Item 3.**Development Application: 134 Oxford Street, Darlinghurst - D/2025/961****File Number: D/2025/961****Summary**

Date of Submission:	7 October 2025
Applicant:	The Trustee for Cirillo Planning Trust c/- Giovanni Cirillo
Architect/Designer:	Lewis Design Group Pty Ltd
Developer:	oOh! Media
Owner:	KDP Nominees Pty Ltd
Planning Consultant:	Planning Lab c/- Giovanni Cirillo
Heritage Consultant:	Urbis
Cost of Works:	\$1,256,458.50
Zoning:	The site is located in the E1 Local Centre zone. 'Signage' (which includes 'advertising structure') is permissible in the zone with consent.
Proposal Summary:	<p>The subject application seeks to modify development consent U92-00273 to allow the replacement of an existing externally illuminated static roof advertising sign (94.55sqm) above the Oxford Hotel with an internally illuminated digital LED roof advertising sign (93.7sqm) and for associated works relating to the access and support structures.</p> <p>The application is referred to the Local Planning Panel for determination as the development contravenes the height of building development standard imposed by the Sydney Local Environmental Plan 2012 (the LEP) by more than 10%.</p> <p>The appli

Figure 5: Site viewed from corner of Flinders and Oxford Streets looking north-west at night

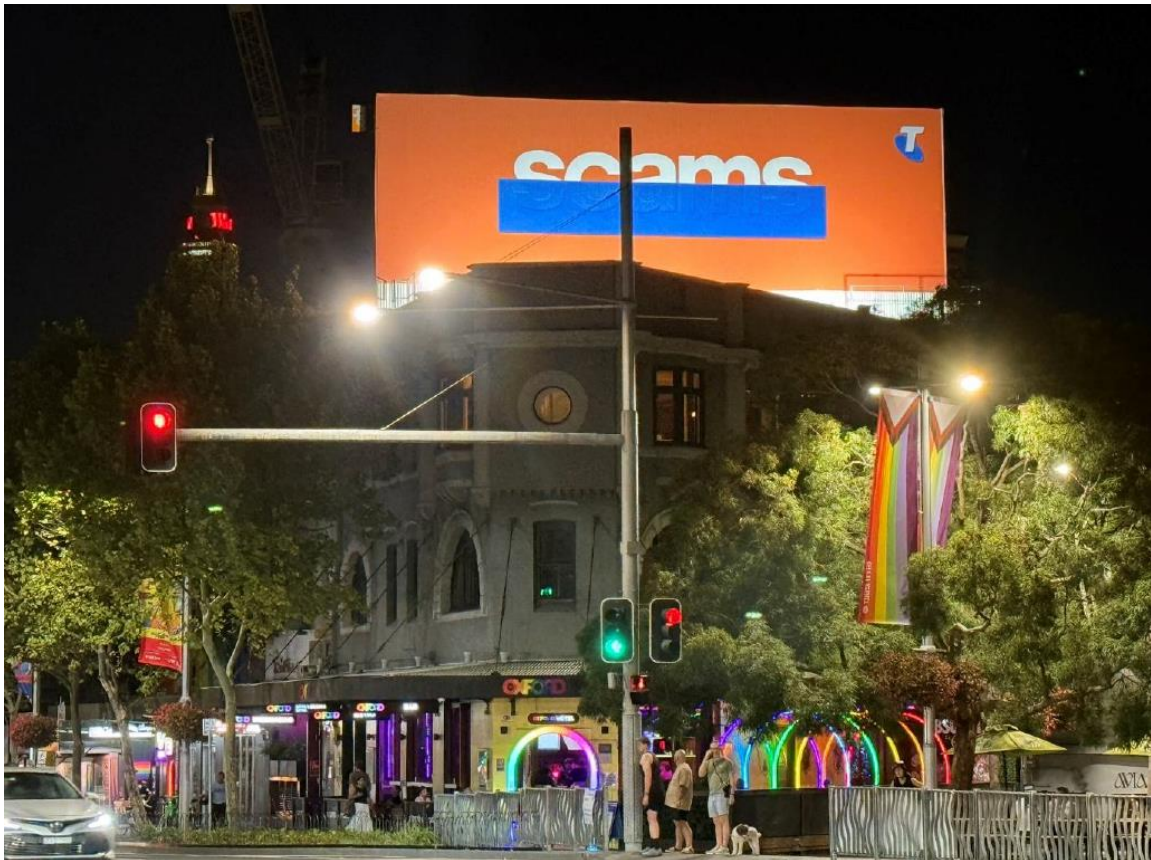
143. The form and content of the rooftop sign have changed from the fixed neon signs of early iterations to the current structure that supports printed vinyl changeable media with external lighting. As shown at Figure 2, the existing sign already has a negative impact on the built form and setting on the Oxford Hotel and the surrounding HCA.

Figure 8: Proposed elevation plans

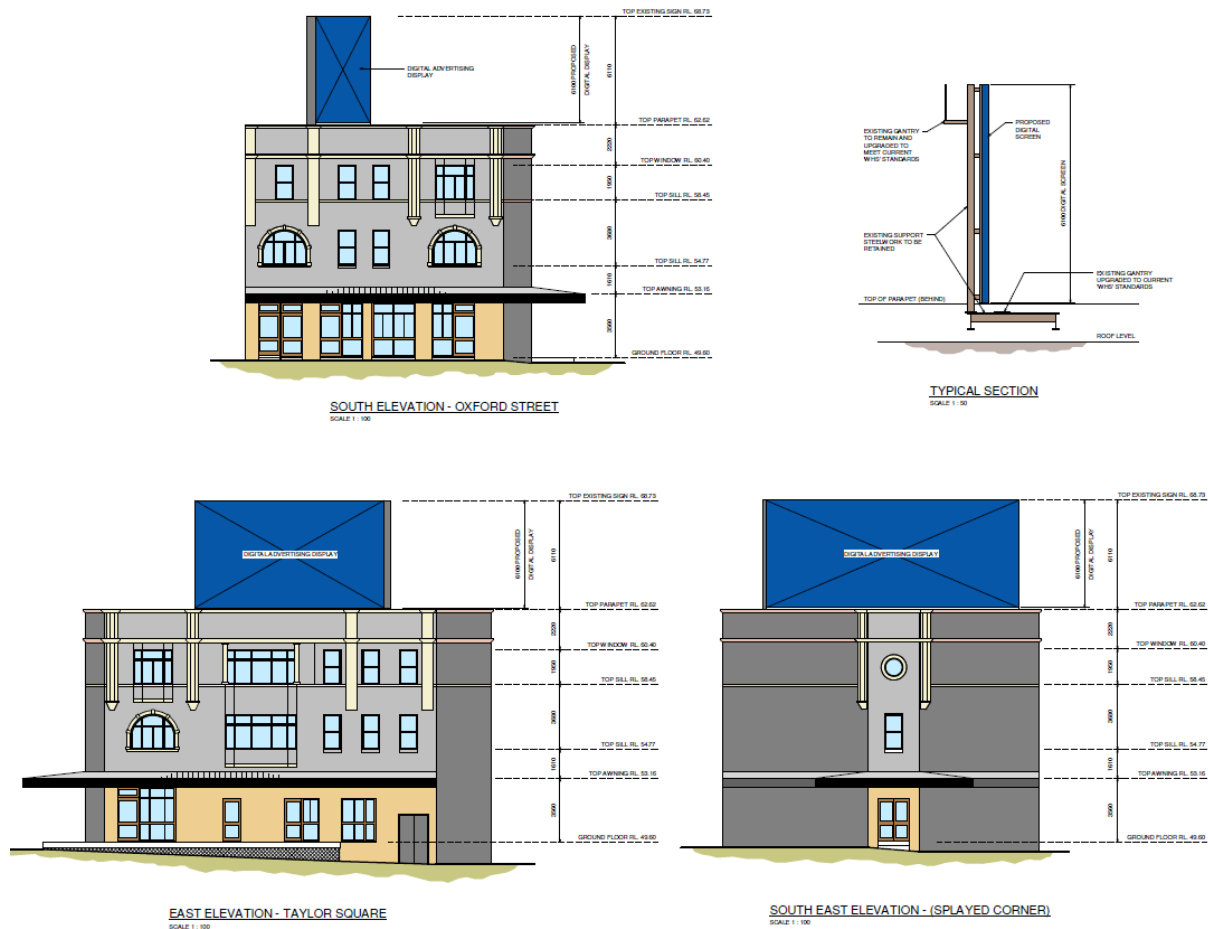
Provision	Compliance	Comment
4.3 Height of buildings	No	<p>A maximum building height of 15m is permitted.</p> <p>A height of 19.13m is proposed.</p> <p>The proposed development does not comply with the maximum height of buildings development standard.</p>

- (c) The written request does not have proper regard for the impacts of the elements that exceed the 15m height standard. The applicant's written request justifies the impacts based on no change to the existing height of the site and fails to justify whether the proposal provides a suitable height transition between it and adjoining heritage items. Stating that existing height will be retained is insufficient to demonstrate that compliance with the standard is unreasonable or unnecessary.

Figure 9: Plan approved under U92-00273 (being the subject base DA for this application)

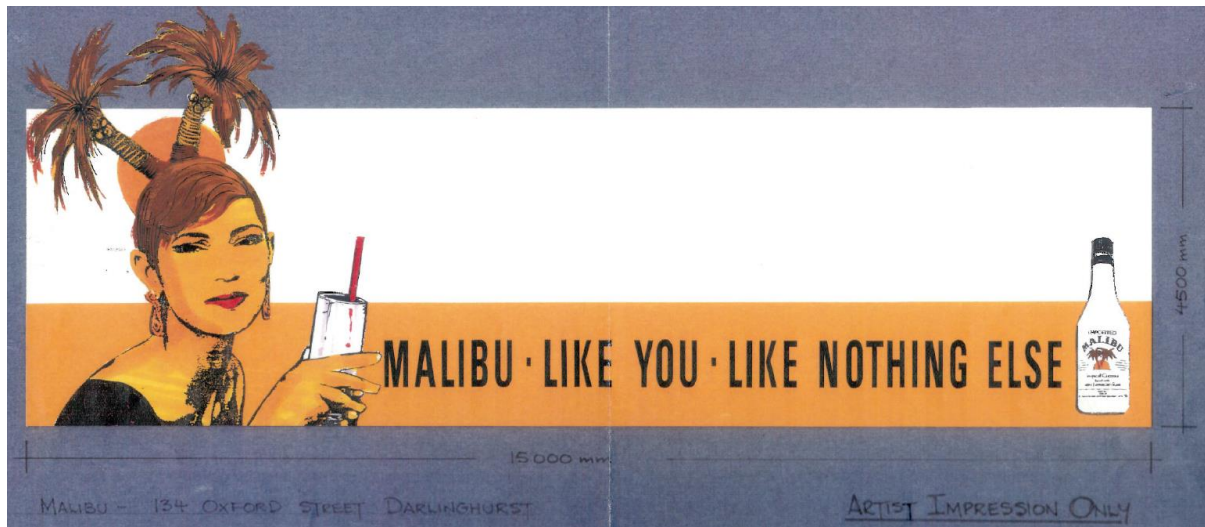
- (ii) The constructed sign has an advertising display area that exceeds that approved by development consent No. U92-00273 given that a large portion of the sign sits outside of the area depicted on the approved unnumbered, undated plan on file No. U92-00273.

72. Further to the above, development consent No. U92-00273 describes the approved development as being the erection of a roof sign 15.5 metres long x 6.1 metres high externally illuminated by flood lights carrying the wording "Malibu Like You Like Nothing Else" **all in accordance with the unnumbered, undated plan held in the above file** (emphasis added).
73. The approved plan indicates that the approved sign has a predominant height of 4.5m, with higher 6.1m elements being limited to point encroachments only (see Figure 9). Based on the approved description of the proposal and associated approved plan, it appears that the existing sign has a significantly larger surface area given that there is a large portion of the sign that sits outside of the area originally granted consent.

Figure 11: Existing structure/gantry shown sitting over the parapet wall to Bourke Street

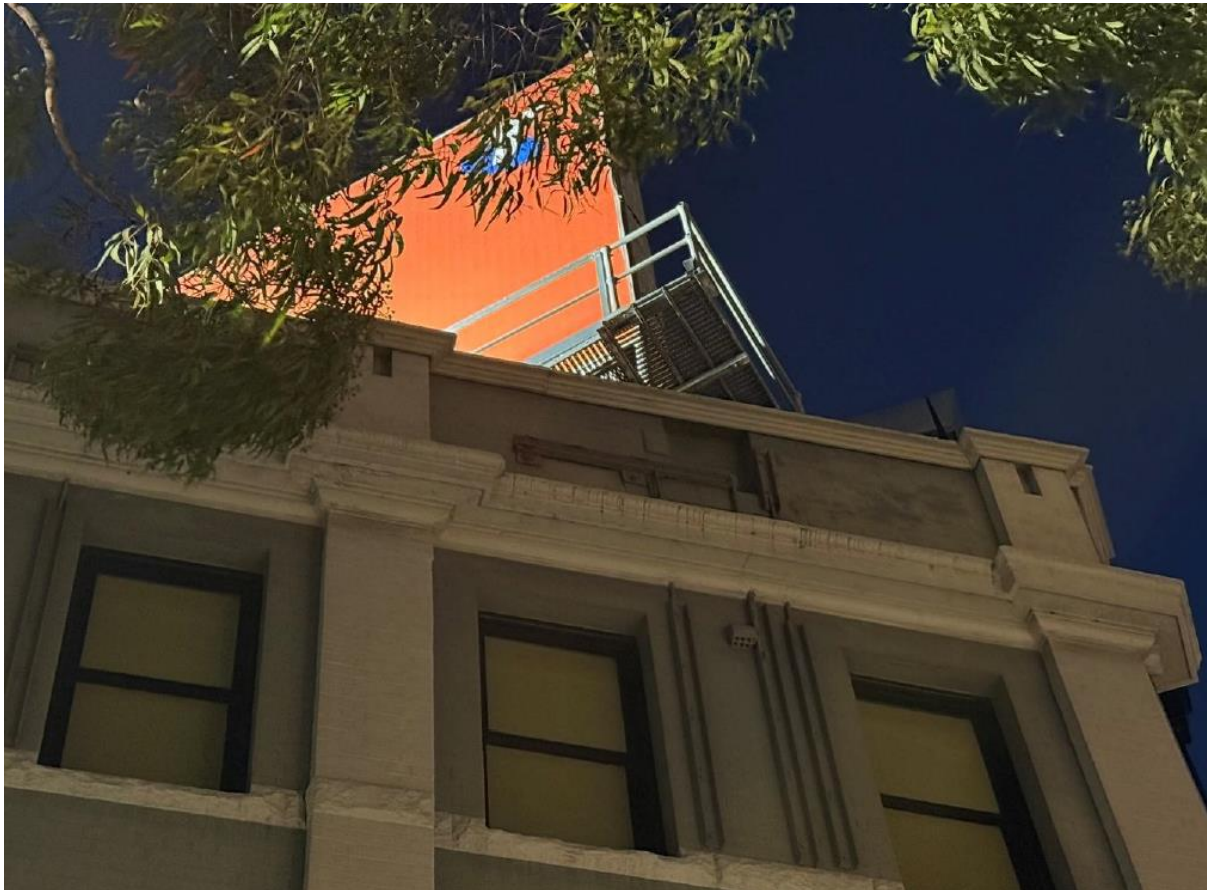
- (iv) details of all encroaching structures. As shown in Figure 11, a portion of the existing structure sits over the parapet wall to Bourke Street/Taylor Square. This element is not depicted on either the existing or proposed drawings. While the drawings note that the existing access gantries will be retained and upgraded to meet current WHS standards, these details have not been provided. Furthermore, it is unclear if any works are proposed/required to the overhanging element, noting that Council's owner's consent to submit the DA is required for any works that encroach outside of the property boundaries. The DA cannot be approved without the relevant owner's consent.

Figure 14: Unauthorised oOh! Media logo sign attached to the existing sign structure

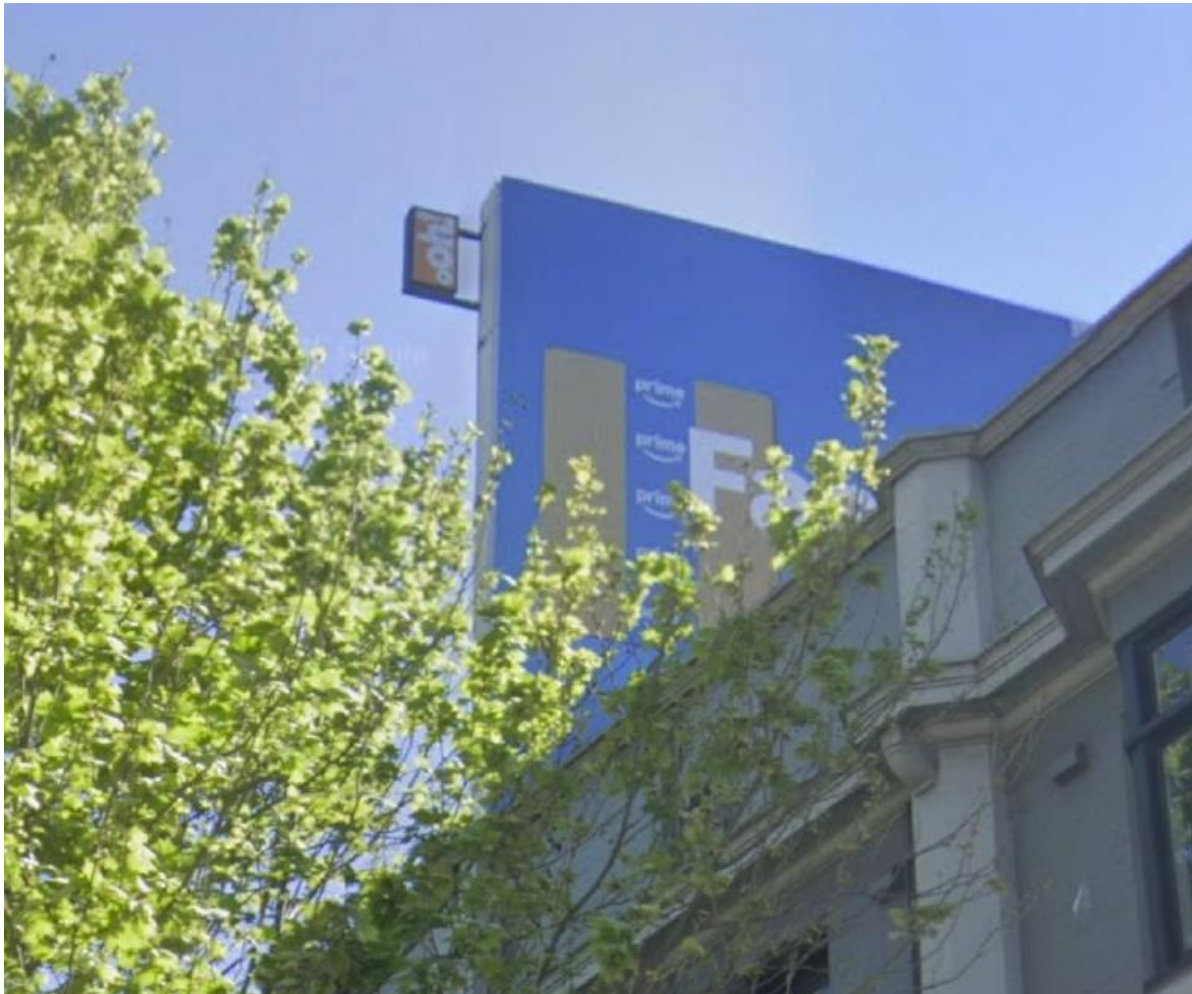
46. While not shown on either the existing or the proposed architectural drawings, it is noted that the existing sign has an illuminated logo sign on its southern edge (see Figure 14). The logo sign was not present in Google Streetview images in April 2008 but appeared in the November 2009 images. This sign sits outside of the overall sign extent and is not an exempt part of the third-party advertising sign.
47. The applicant is of the opinion that the non-compliance with these provisions is justified because the logo sign has historically been in place. Council officers disagree with this opinion.

- (ix) details of the continual power supply for the electronic advertising structure as required by Sections 3.16.4(6) and 3.16.7.2(2)(k) of the DCP
- (x) amended plans showing the demolition of the existing illuminated 'oOh' logo sign (see Figure 14). This sign was not present in Google Streetview images in April 2008 but appeared in the November 2009 images. This sign sits outside of the overall sign extent and therefore is not an exempt part of the third-party advertising sign. While this portion of the sign does not appear on the proposed architectural drawings, no demolition details have been provided to confirm its removal.
